**Agenda**  
**City of Springboro Planning Commission Meeting**  
**Wednesday, August 20, 2025, 6:00 p.m.**  
**Council Chambers, City Building, 320 West Central Avenue**

**Final Development Plan, 605 North Main Street, Easton Farm PUD-MU, Planned Unit Development-Mixed Use, multi-family residential component**

City staff recommends approval of the final development plan for the multifamily component of the Easton Farm PUD-MU contingent on addressing the following comments:

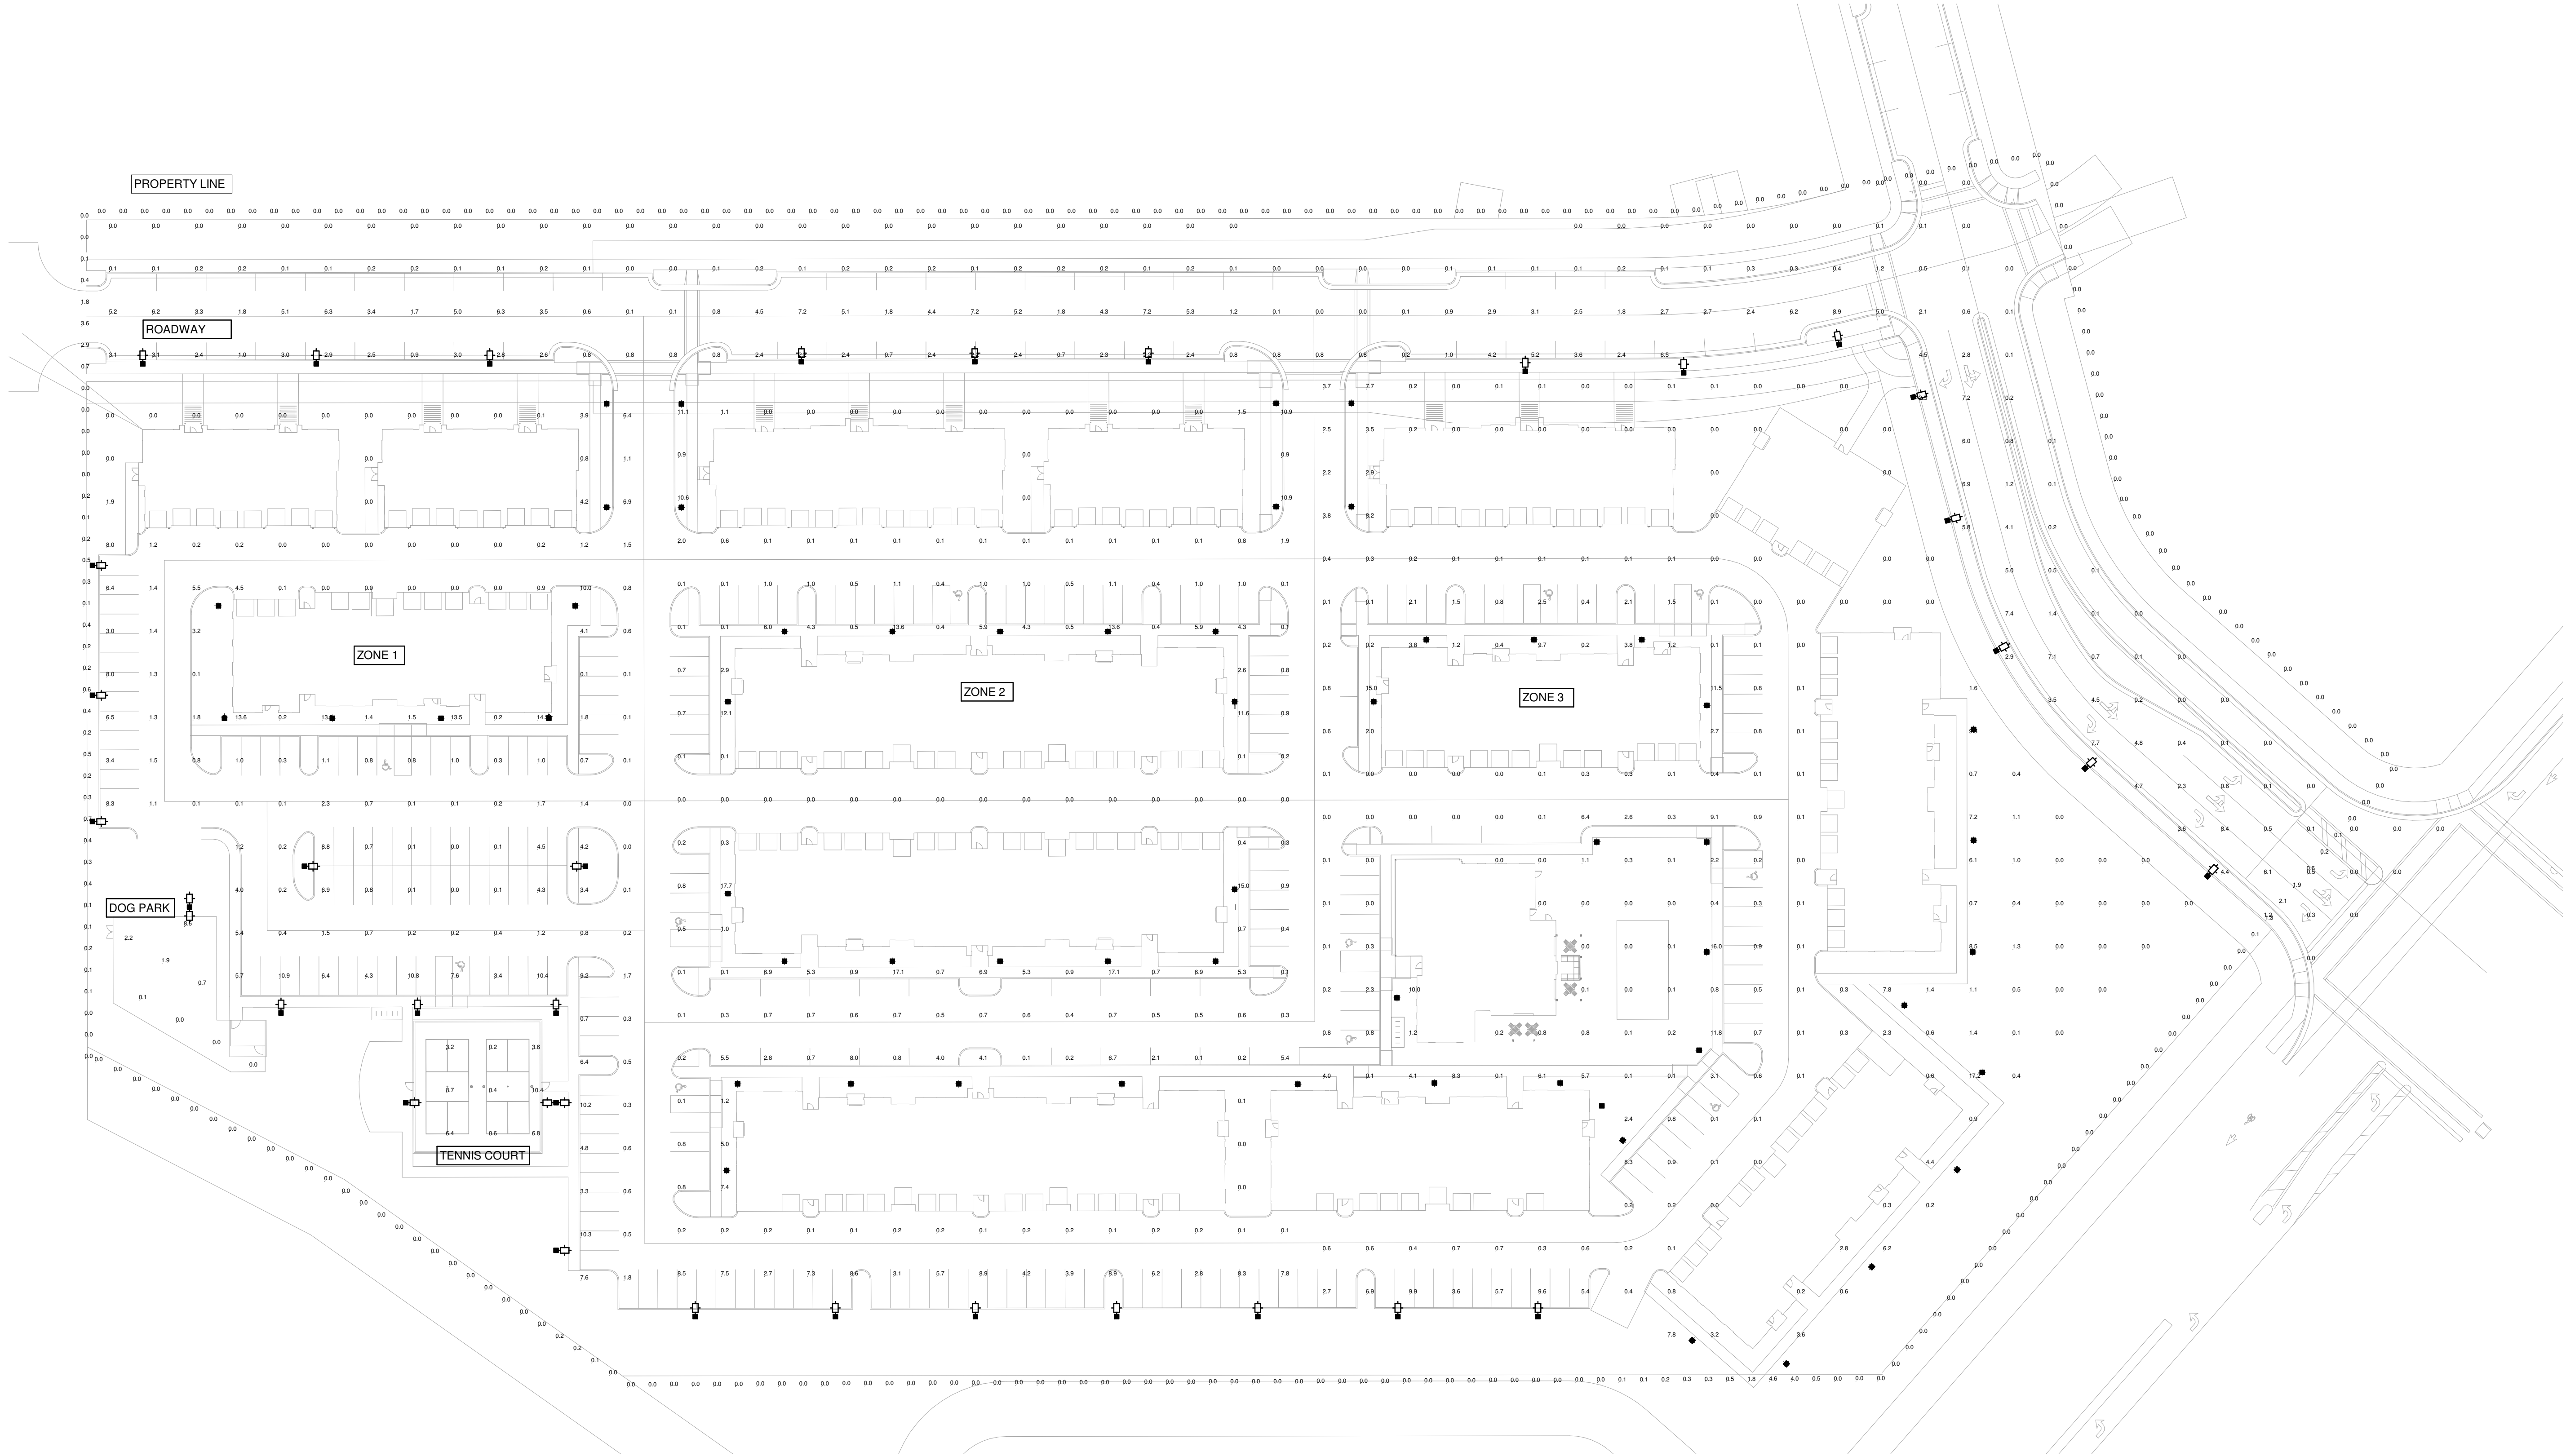
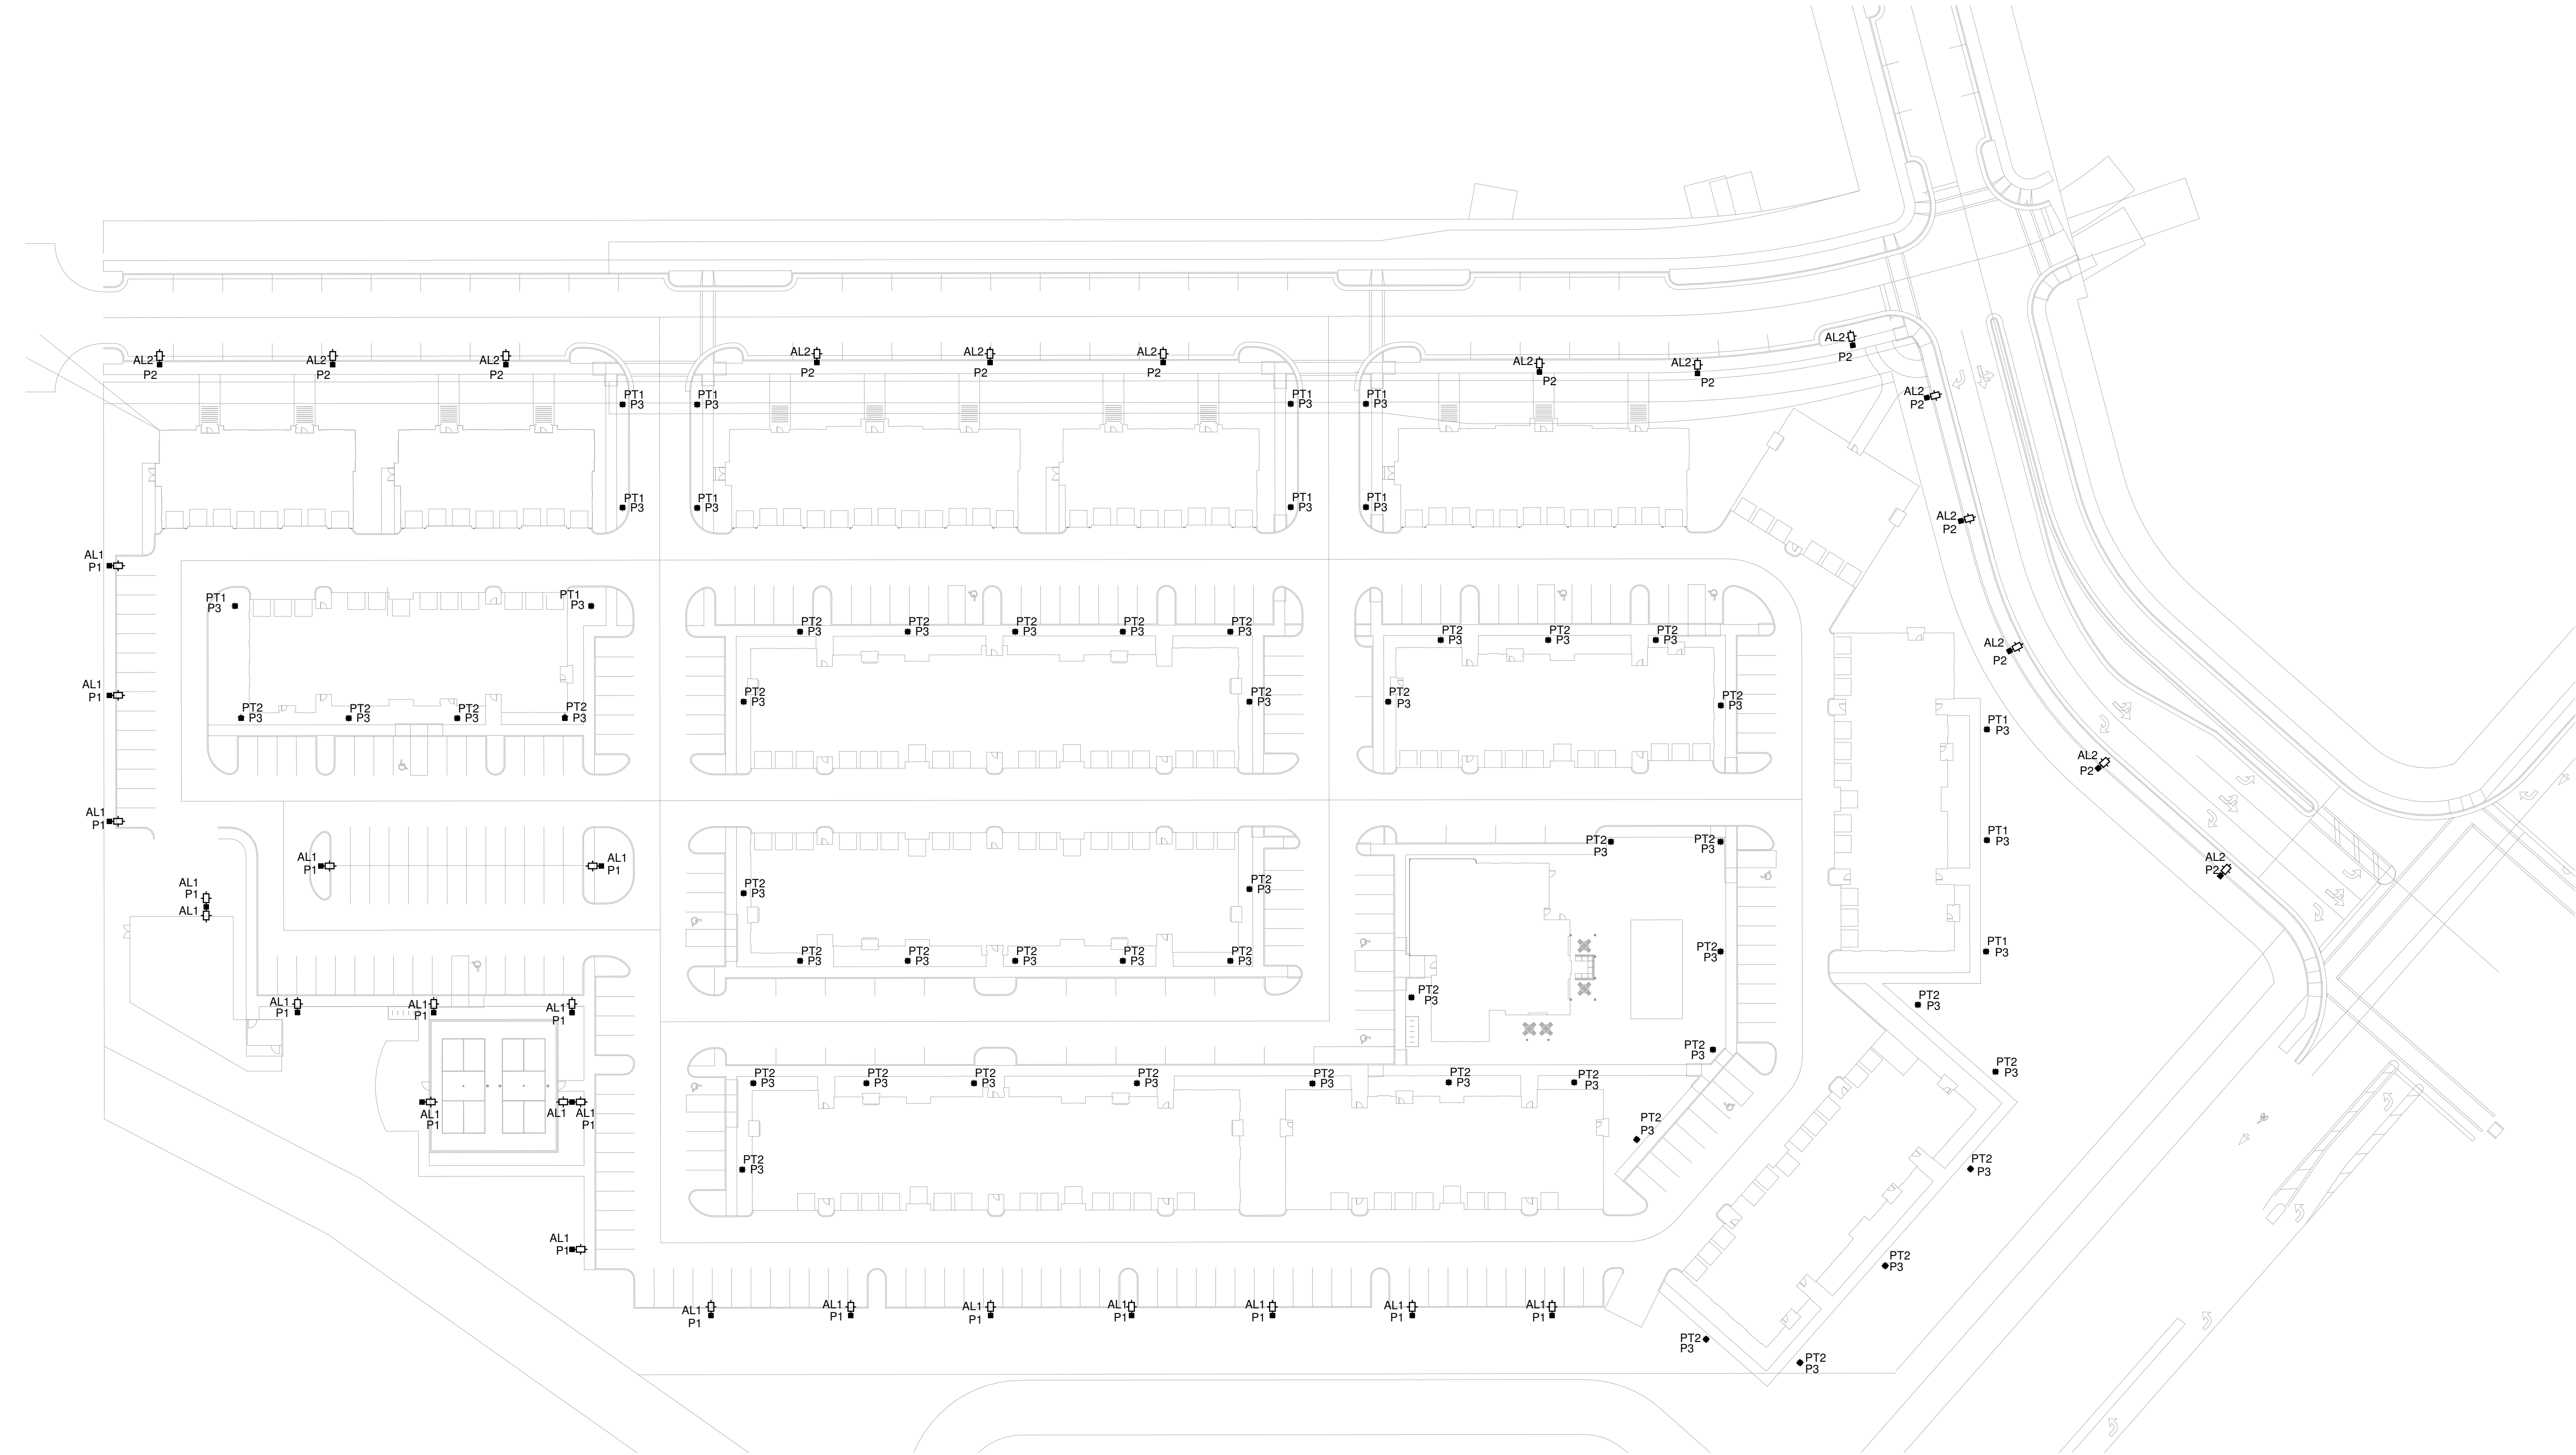
2. Proposed lighting fixtures are consistent with Chapter 1273, Exterior Lighting, of Planning and Zoning Code and Dark Sky provisions. The following needs to be addressed in the plan on sheet E4-201:

- d. Lighting (AL2 P2) in adjacent public right-of-way is outside this review.
3. For landscaping plan, please address the following:
  - a. On sheet L2.0, under Site Landscaping remove statement \*Buffer trees count towards this requirement. They do not, however, the number of trees provided appears to meet standard.
